PCN Number: 1604-2  
Chgnot.doc rev. \_\_ 2/16

### Product/Process Change Notification (PCN)

**Customer:** NEWARK ELECTRONICS

**Date:** 24 August 2016

## Legacy UA vs Matrix HD UA - Visual Differences

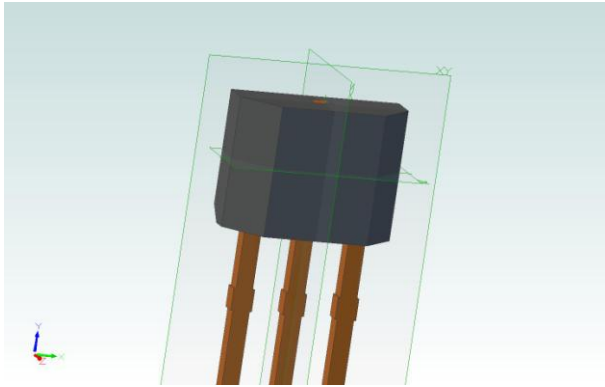
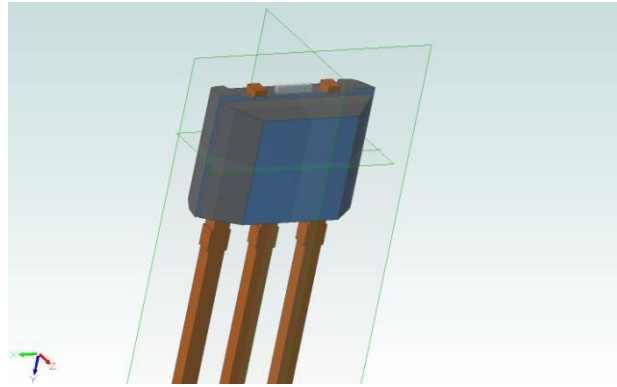
- Top of package on the Matrix HD UA has tie and dam bar protrusions

## Legacy UA vs Matrix HD UA – Leadframe Differences

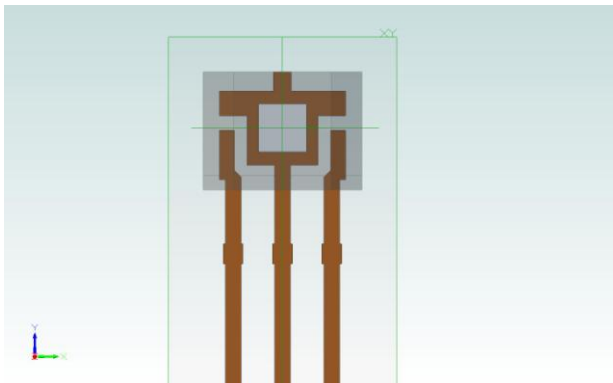
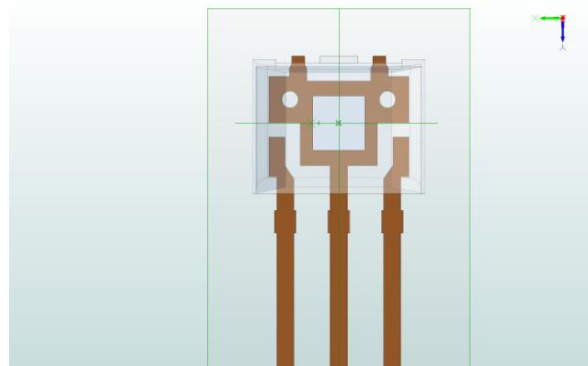
Legacy UA leadframe

Matrix HD UA leadframe

## Legacy UA vs Matrix HD UA – Dimensional Comparison

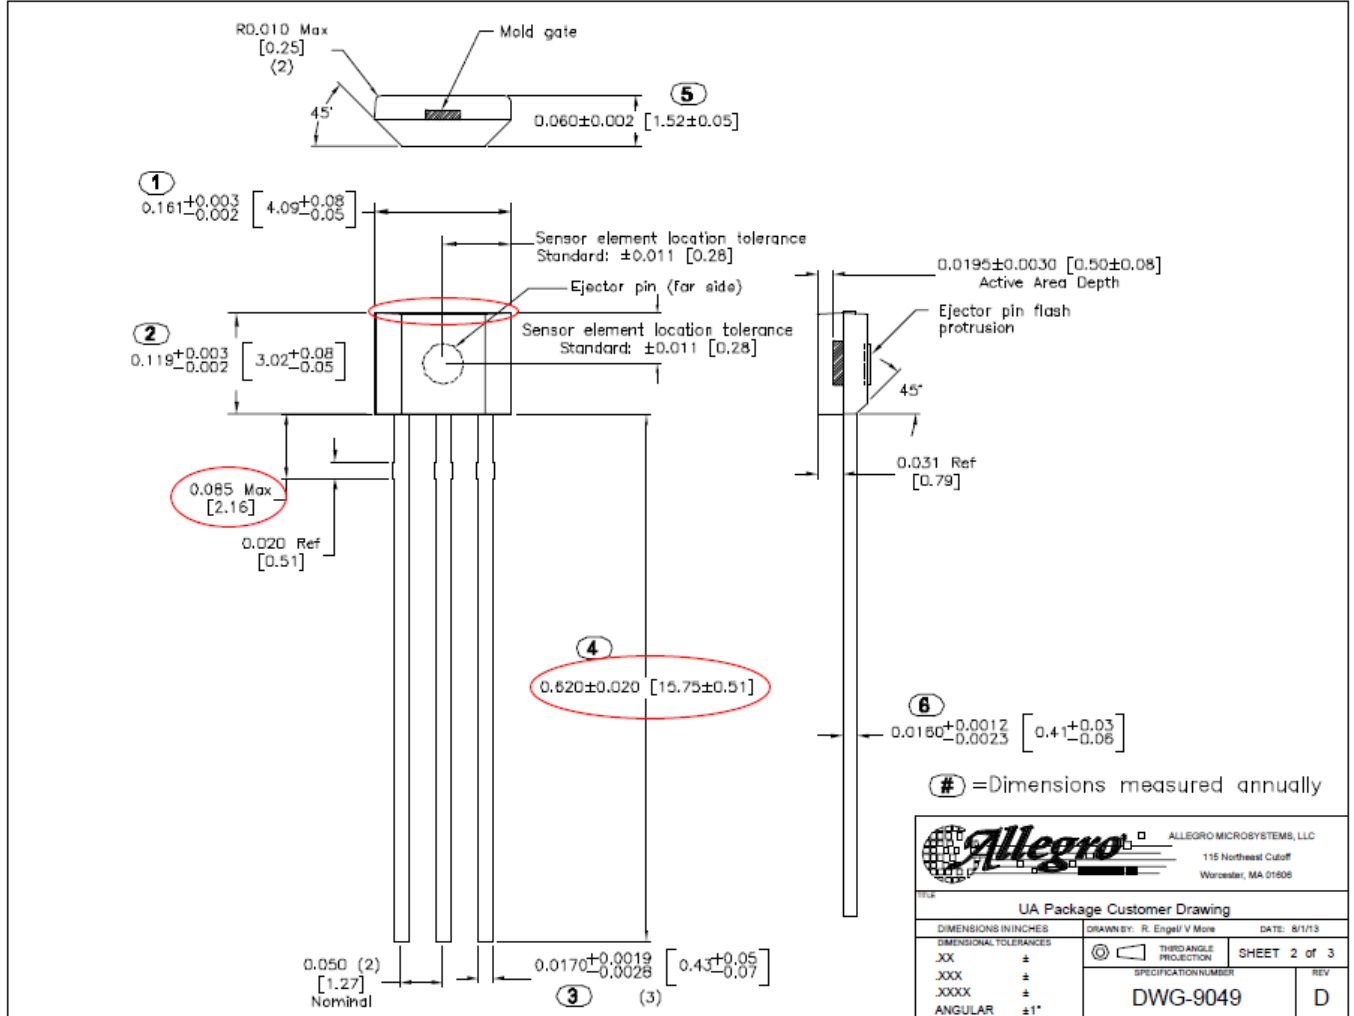
Allegro's legacy UA package. Please reference DWG-0949.

Package lead length: 15.75 +/- 0.51 mm

Dam bar from package: 2.16 mm

## Legacy UA vs Matrix HD UA – Dimensional Comparison Continued

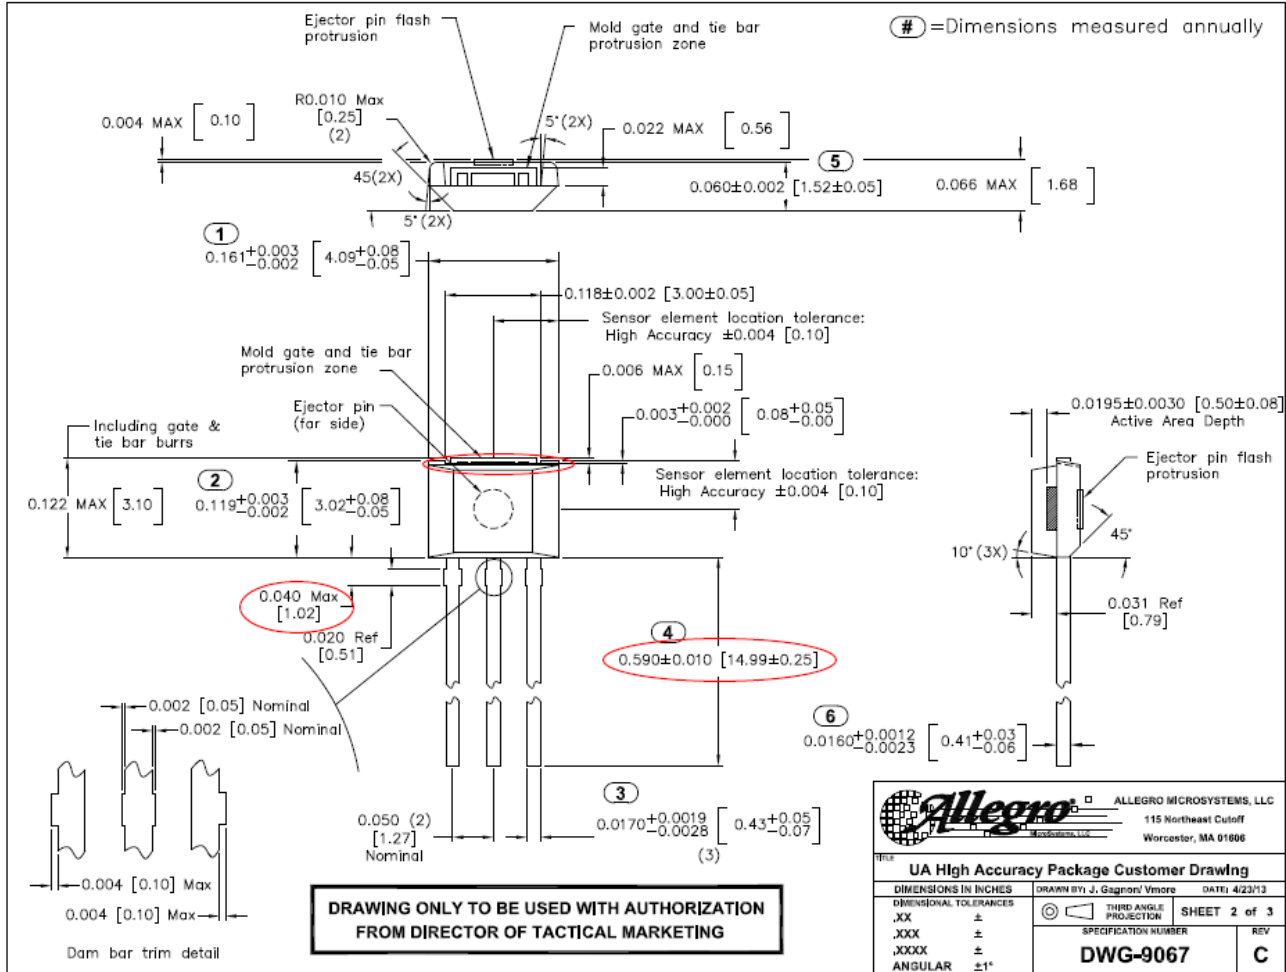
Allegro's Matrix HD UA package. Please reference DWG-9067.

Package lead length: 14.99 +/- 0.25 mm

Dam bar from package: 1.02 mm

Package	Width (mm)	Height (including tie & gate bar protrusions) (mm)	Lead Length (mm)	Leadframe Mold Offset (mm)
Legacy UA	4.09 (+0.08, -0.05)	3.02 (+0.08, -0.05)	15.75 +/-0.51	+/-0.101
Matrix HD UA	4.09 (+0.08, -0.05)	3.02 (+0.08, -0.05)	14.99 +/-0.25	+/-0.051
